PRELIMINARY/FINAL DRAINAGE REPORT

SOUTH ACADEMY BUSINESS CENTER

**Prepared By:
Associated Design Professionals, Inc.
3520 Austin Bluffs Parkway, Suite 102
Colorado Springs, CO 80918
(719) 266-5212
Project No. 161103
1/25/18
PCD Project No 17-004**

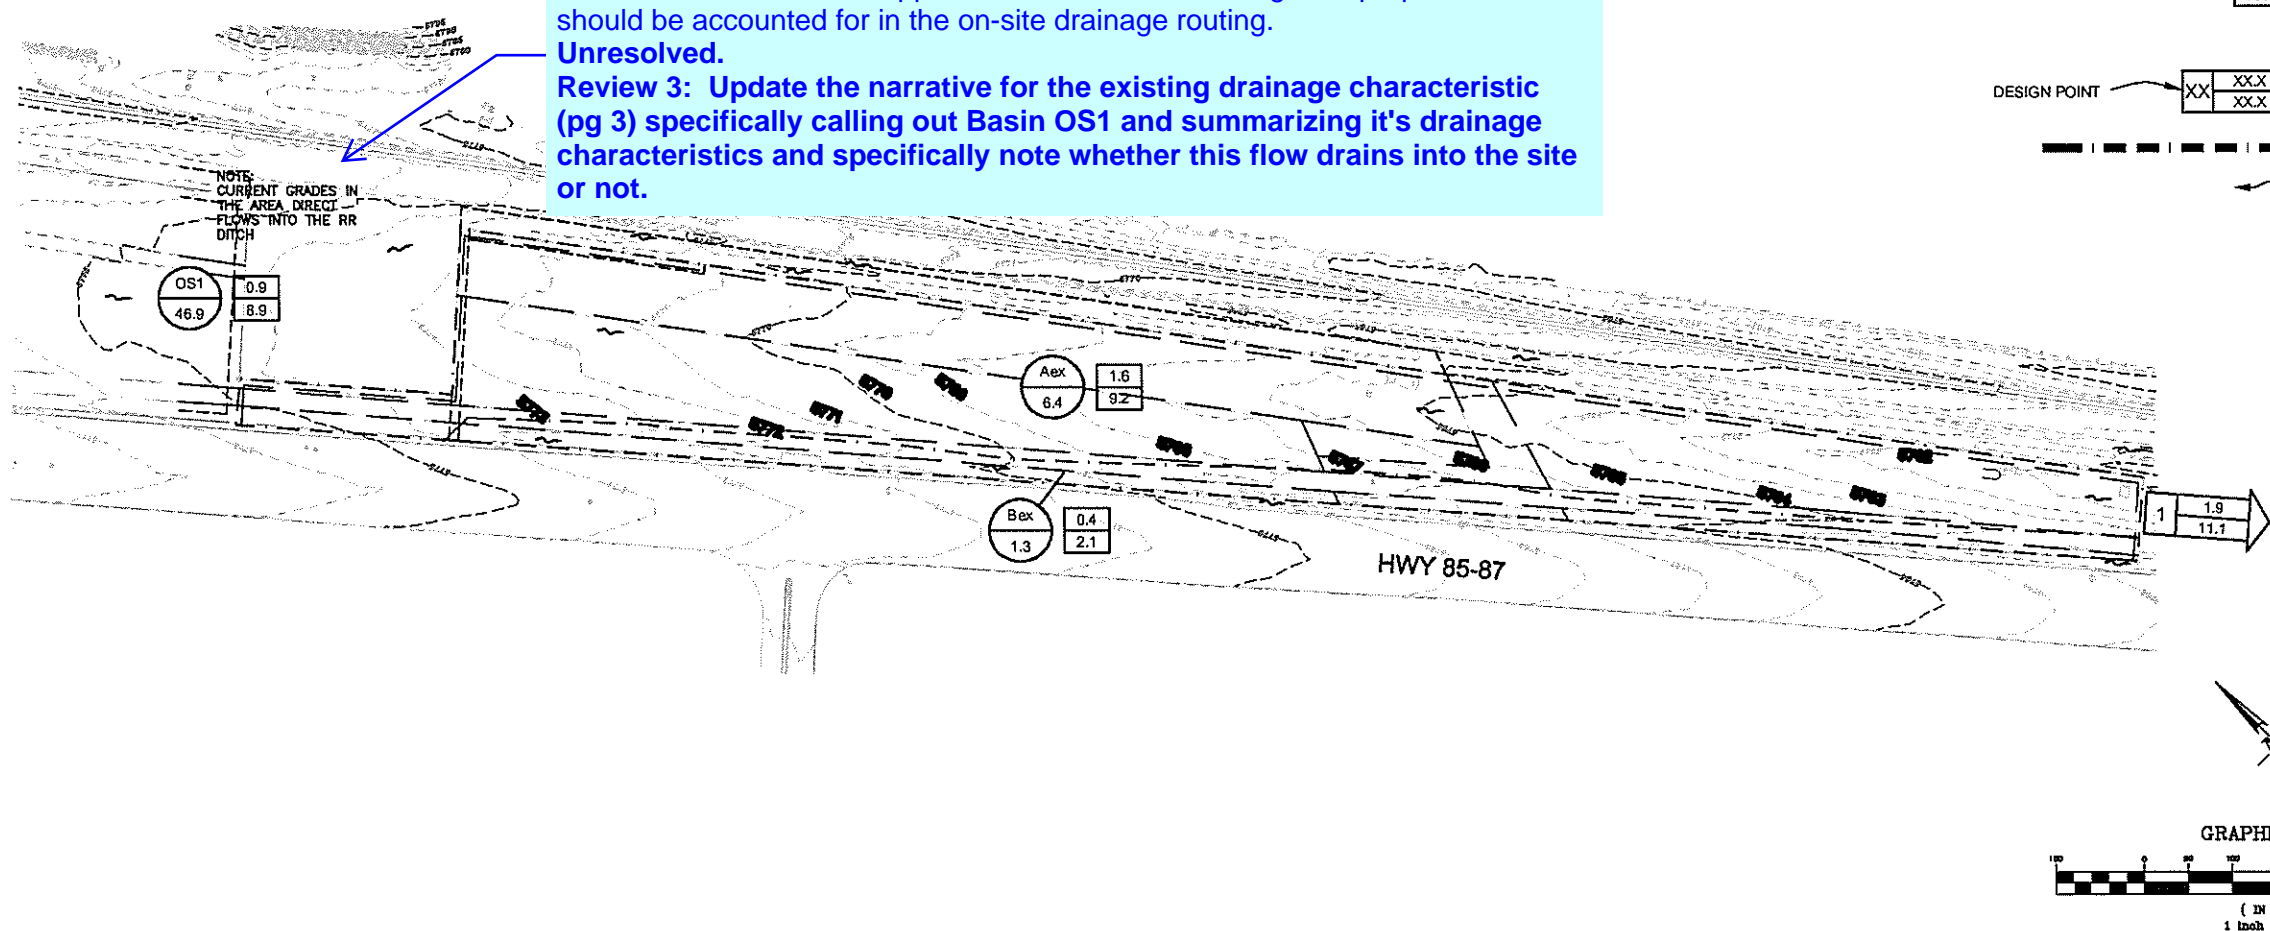
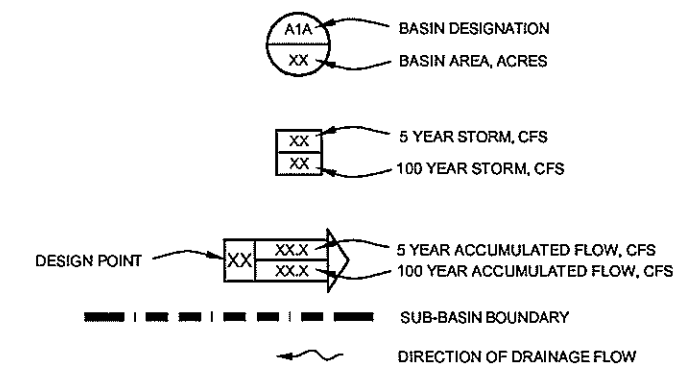
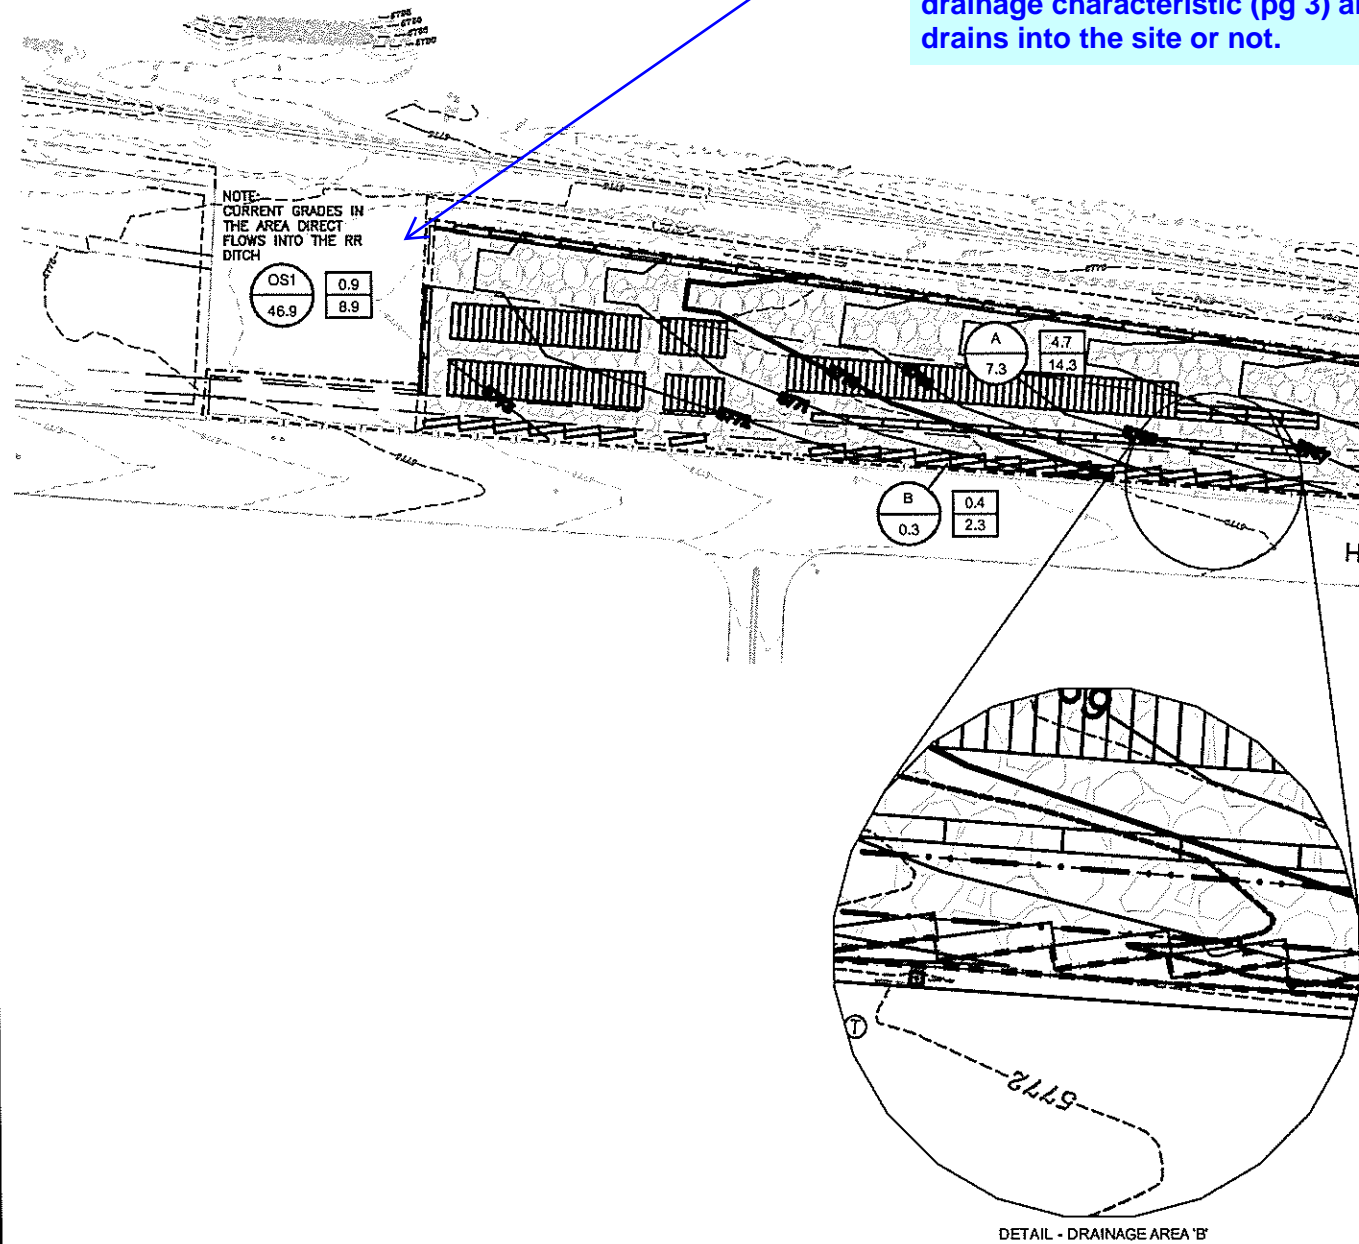
Include in the rational method calculation in Appendix B and describe/summarize in the narrative section of the report. Based on the contours it appears that this drains through the proposed site and should be accounted for in the on-site drainage routing.

Unresolved.

Review 3: Update the narrative for the existing drainage characteristic (pg 3) specifically calling out Basin OS1 and summarizing it's drainage characteristics and specifically note whether this flow drains into the site or not.

DRAINAGE PLAN - PROPOSED CONDITIONS

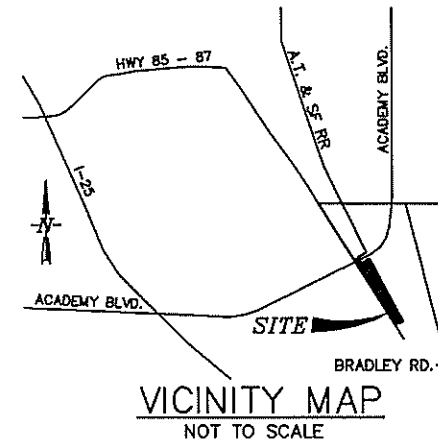
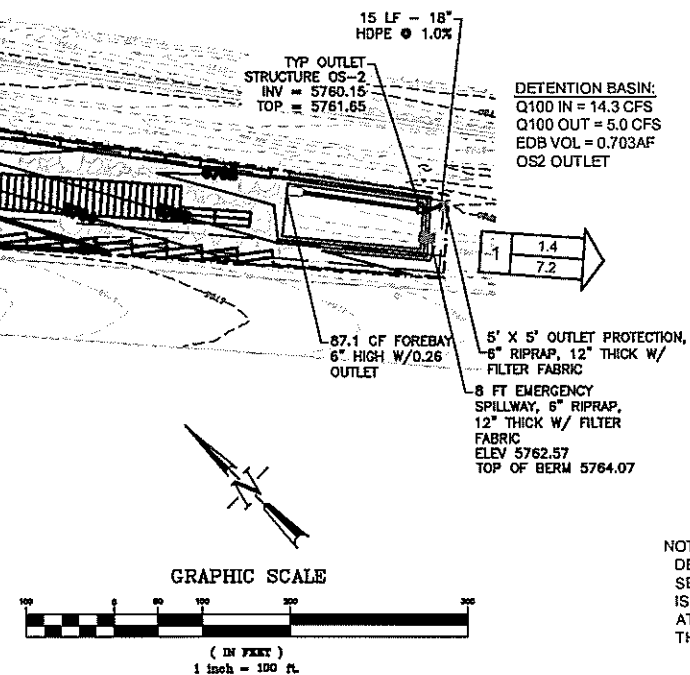
Include in the rational method calculation in Appendix B and describe/summarize in the narrative section of the report. Based on the contours it appears that this drains through the proposed site and should be accounted for in the on-site drainage routing.
Unresolved.
Review 3: Provide a subbasin summary for Basin OS1 in the existing drainage characteristic (pg 3) and specifically note whether this flow drains into the site or not.
